City of Portland, Maine – Building or Use Permit Application 389 Congress Street, 04101, Tel: (207) 874-8703, FAX: 874-8716

BUILDING PERMIT REPORT

REASON FOR PERMIT: To Construct a 16x20 - 16x16' additions

HANSON PLOT PLAN
 16 BUTTONWOOD LN.
 PORTLAND, ME.

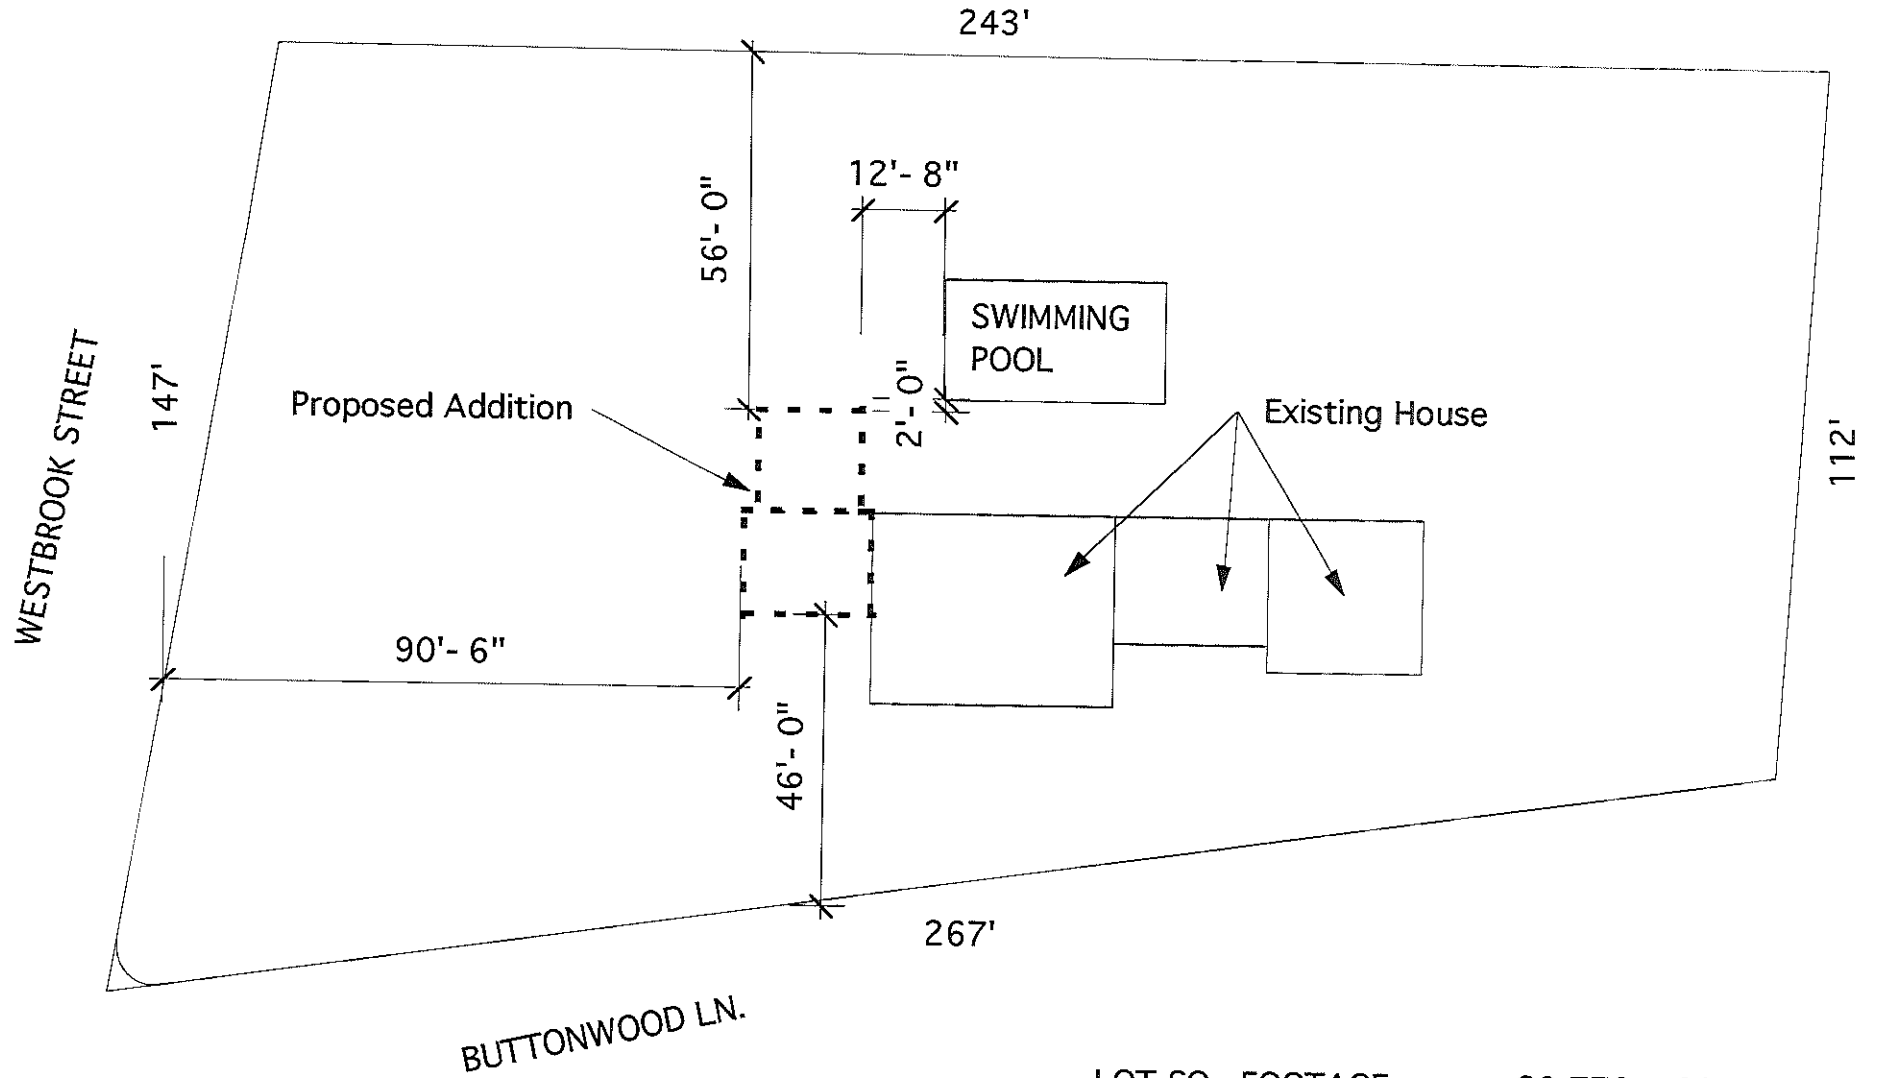
Front Yard - 25' req - 40' shown

Rear Yard - 25' req - 56' shown

Side Yard - 20' from side street side - 40' shown

Width of Lot - 80' req - 267' shown

Lot Area - 10,000^{sq ft} req 39,778^{sq ft} shown

Lot Coverage/Impervious Surface - 20% max or 7955.6^{sq ft} max

HANSON FRAMING SECTION
16 BUTTONWOOD LN.
PORTLAND, ME.

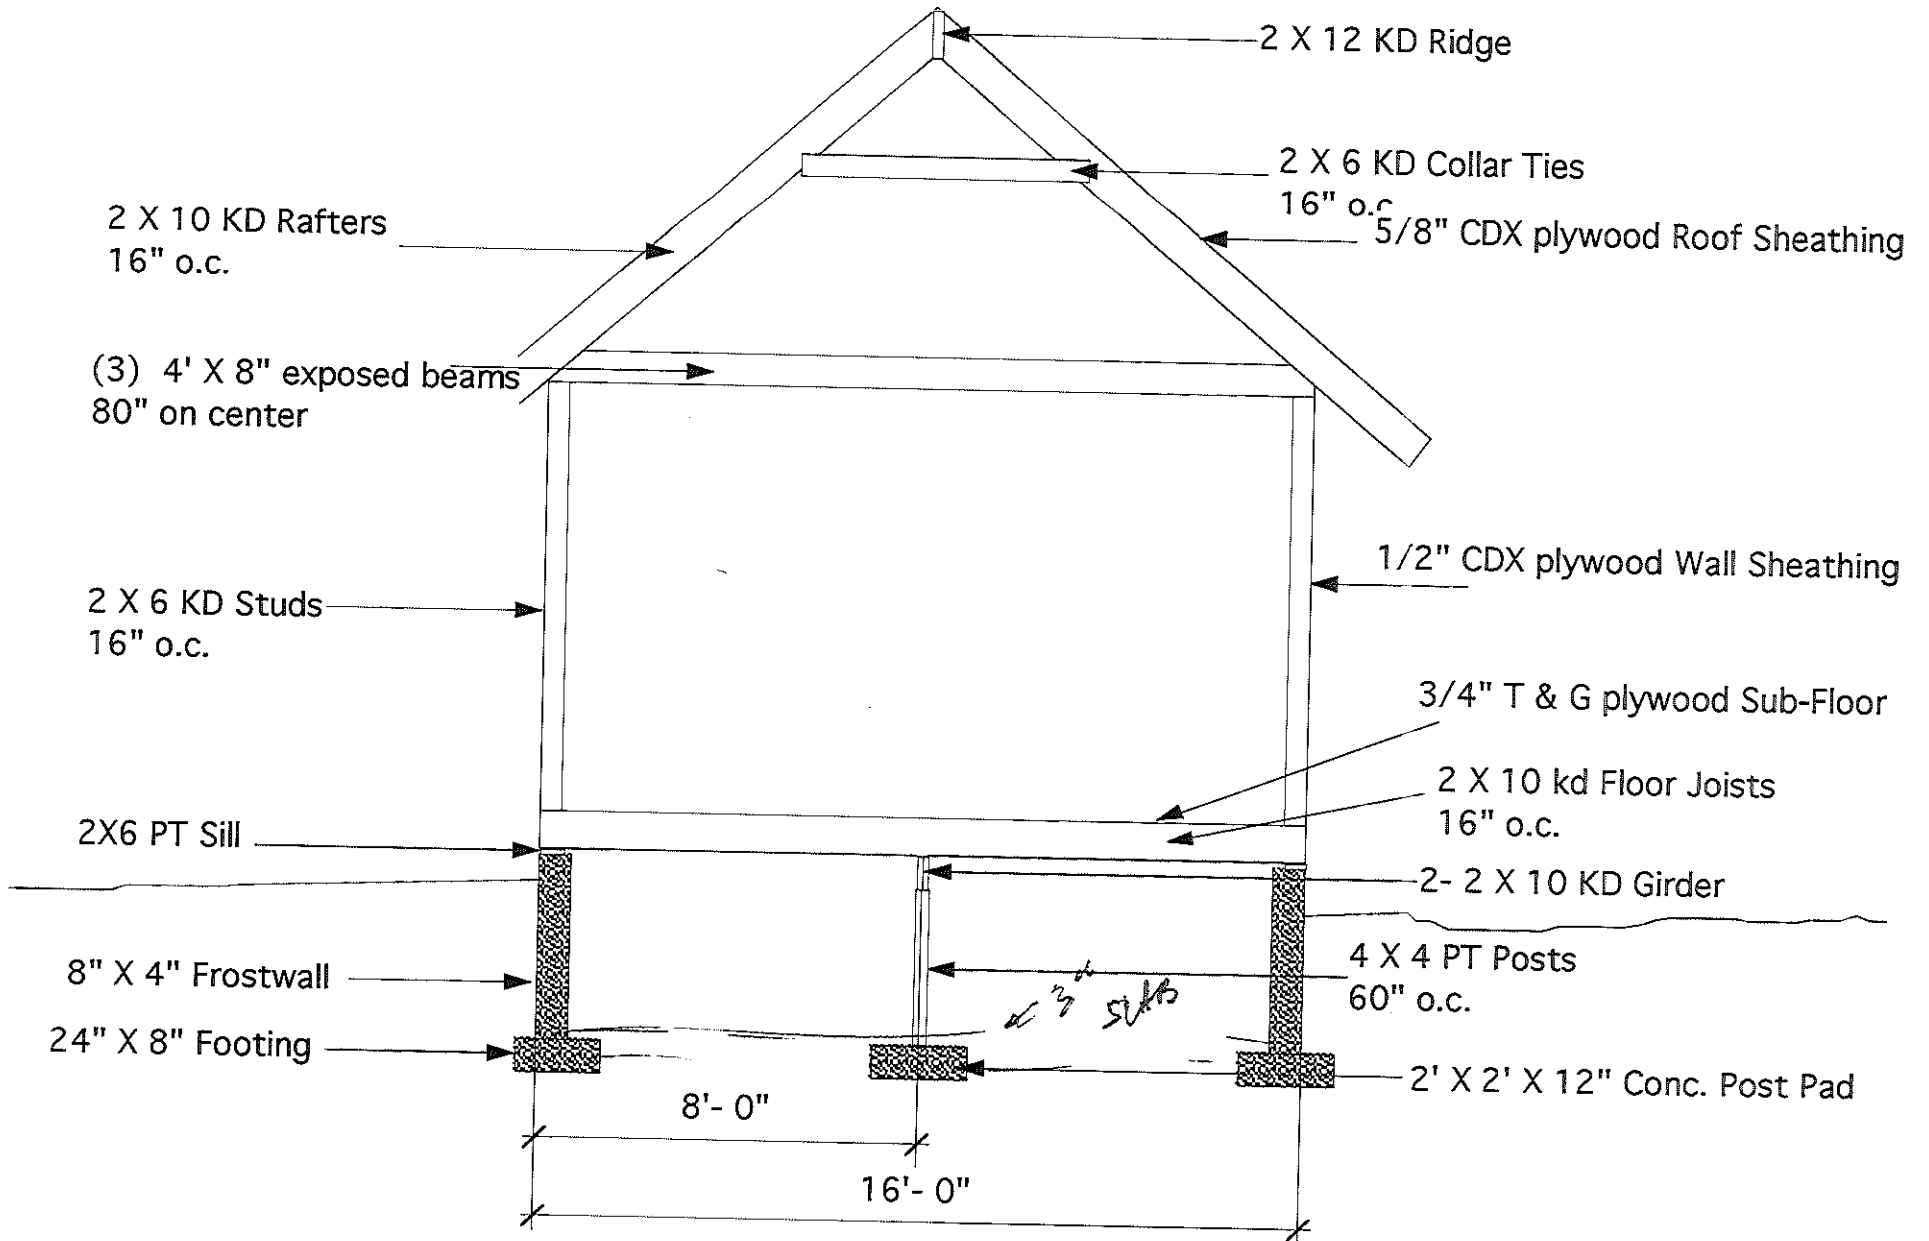
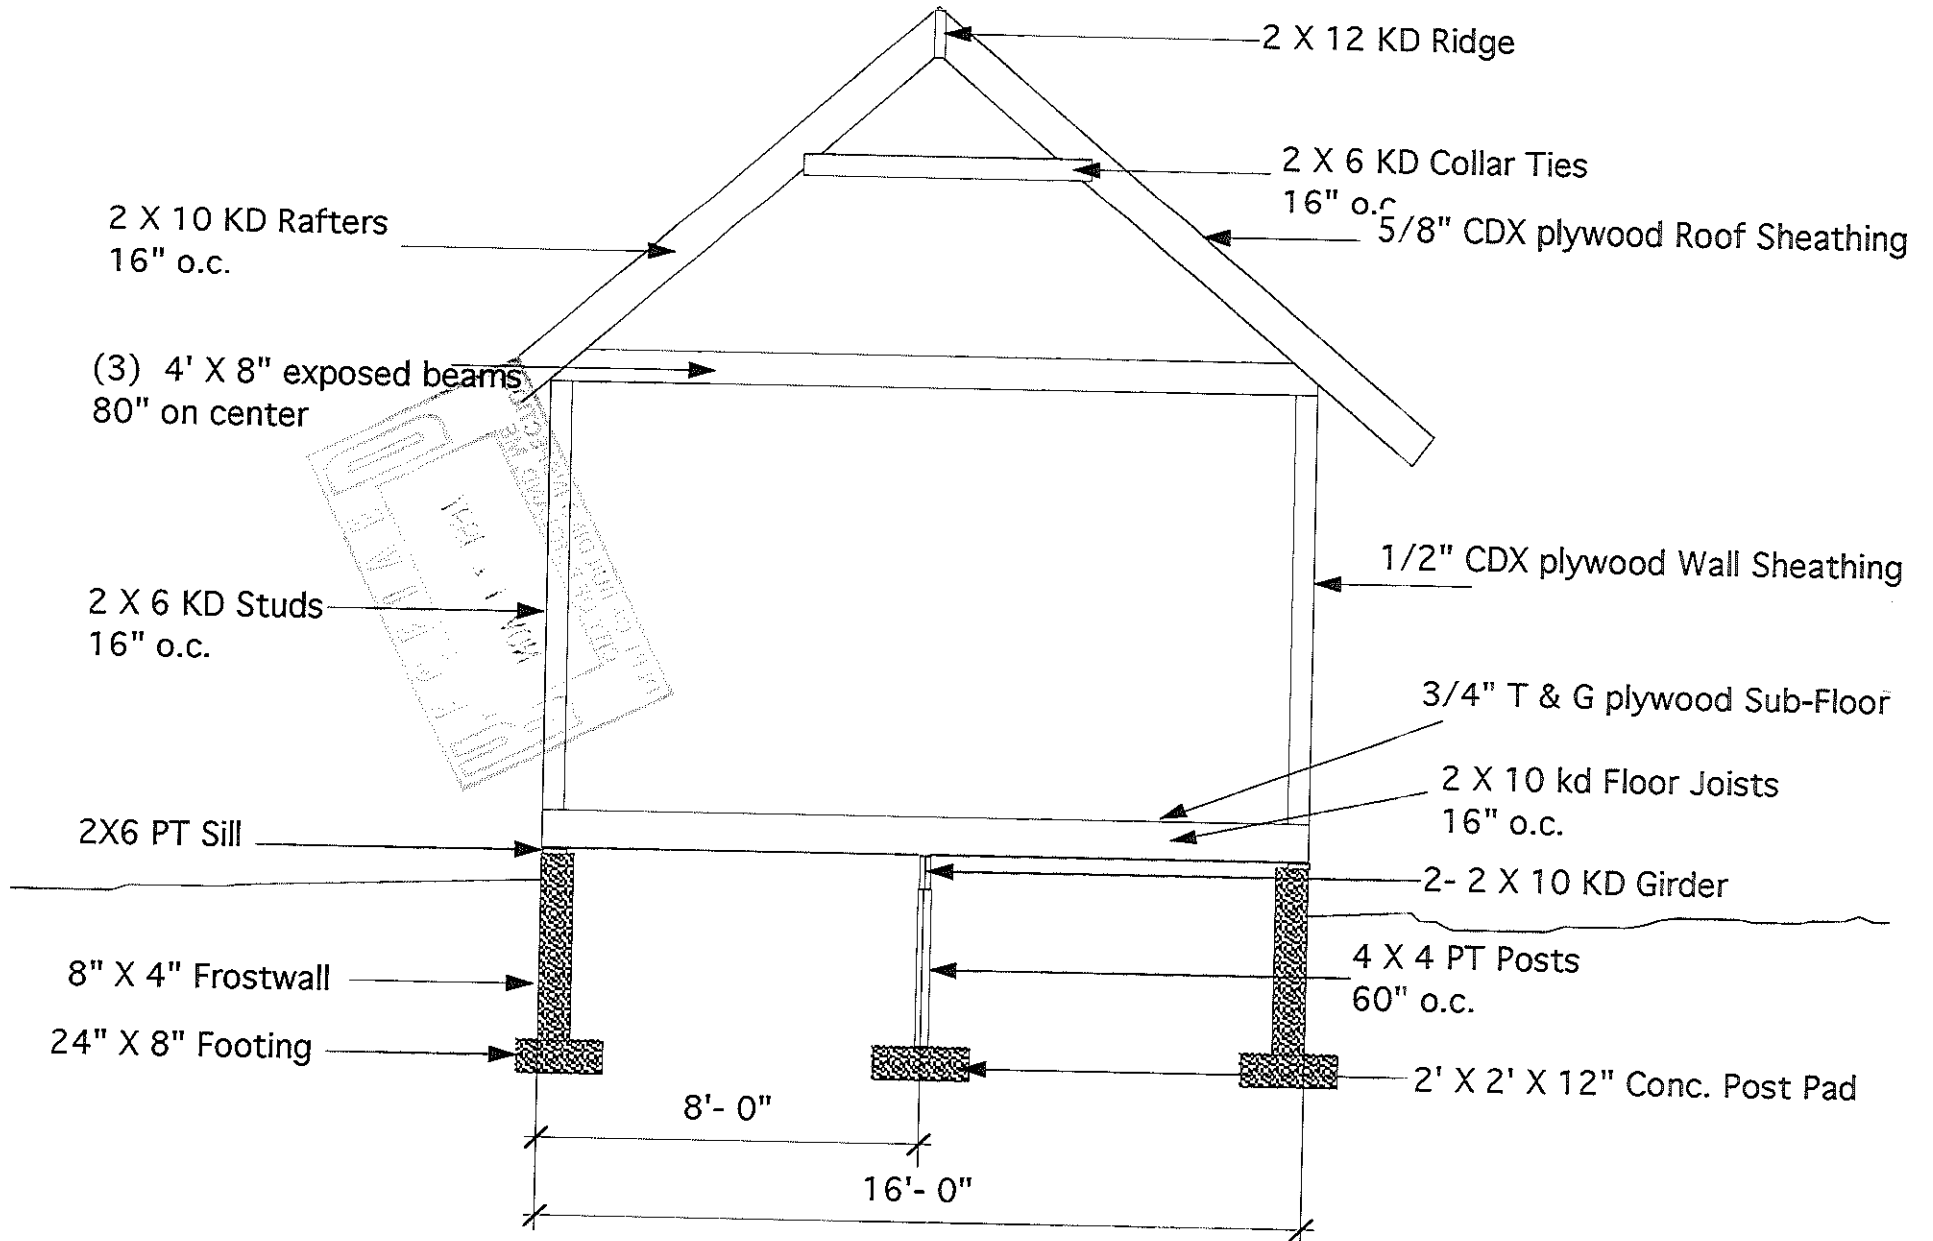
30. *The proposed addition shall be secured to the existing frame*
31. _____
32. _____
33. _____
34. _____

HANSON PLOT PLAN
16 BUTTWOOD LN.
PORTLAND, ME.

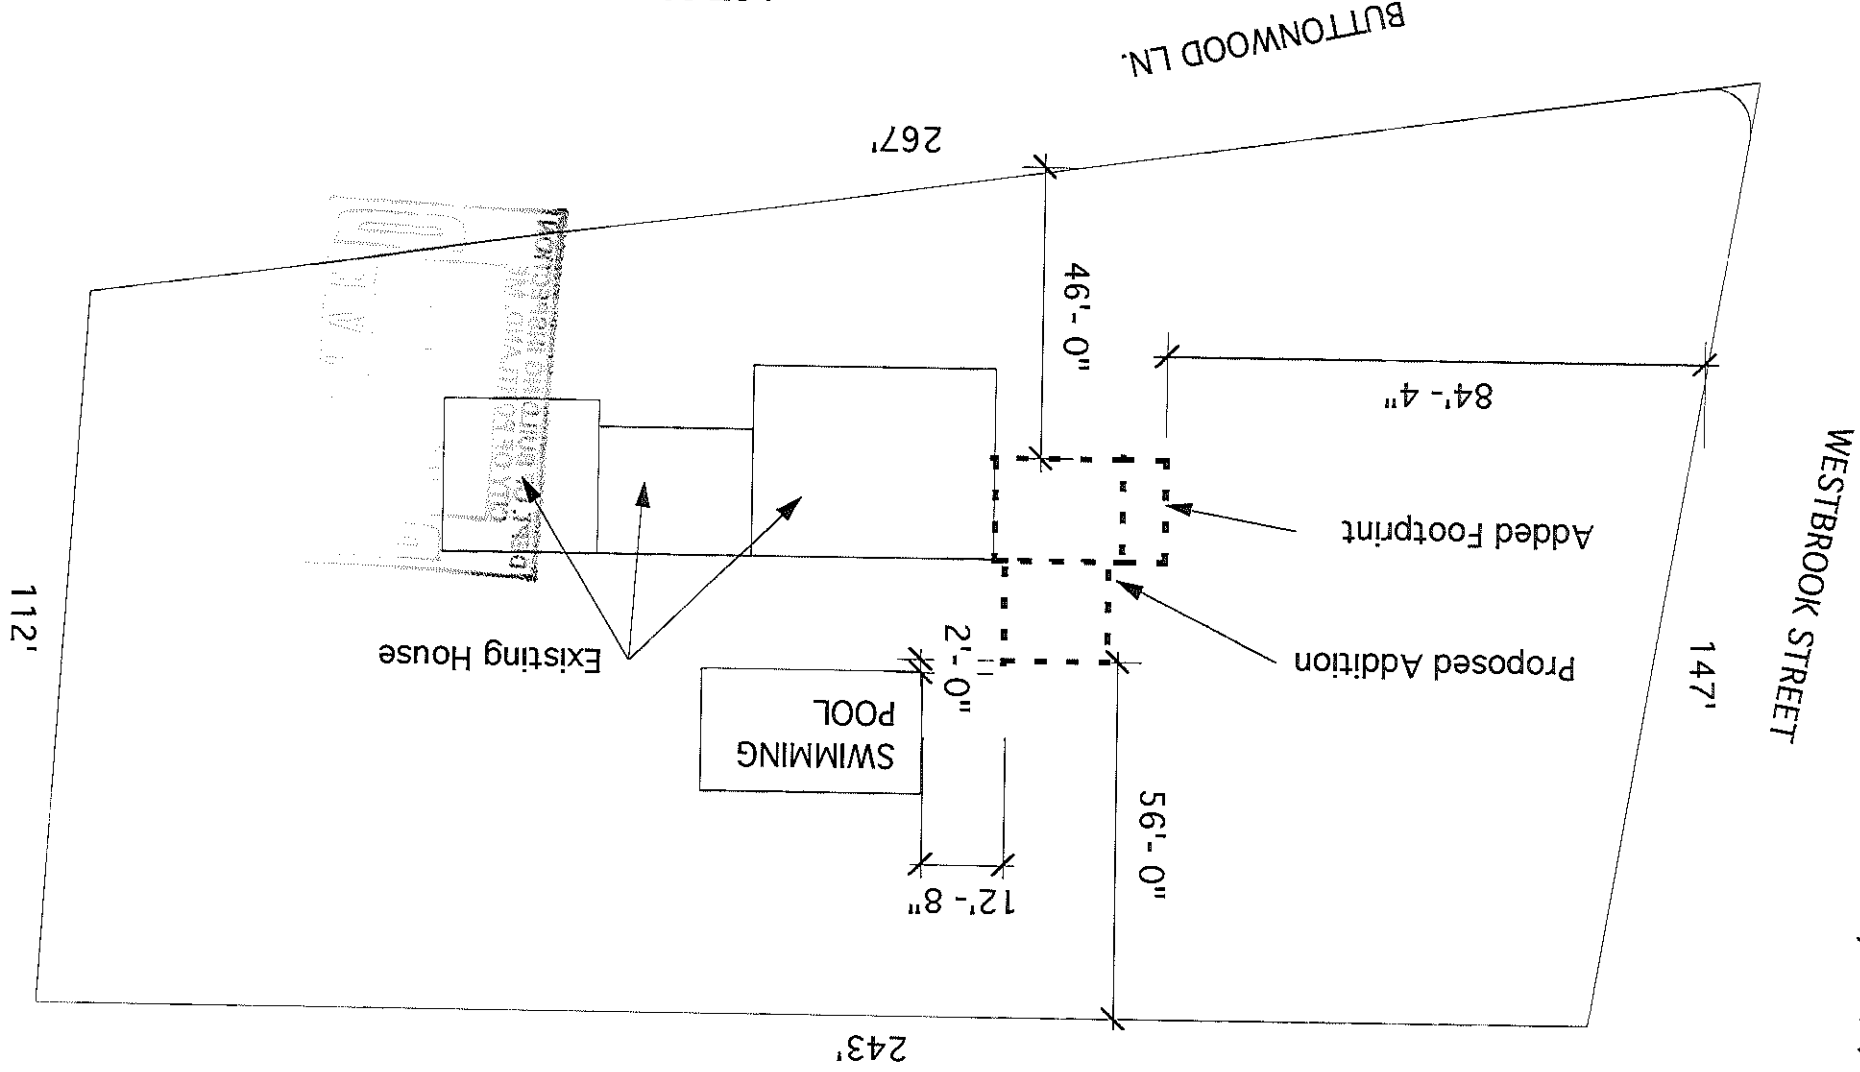
Increase addition size 6 x 16 additional

LOT SQ. FOOTAGE: 39,778 SQFT.
EXISTING LIVING SPACE: 3182 SQFT.
NEW ADDITION: 696 SQFT.
TOTAL NEW LIVING SPACE: 3878 SQFT.
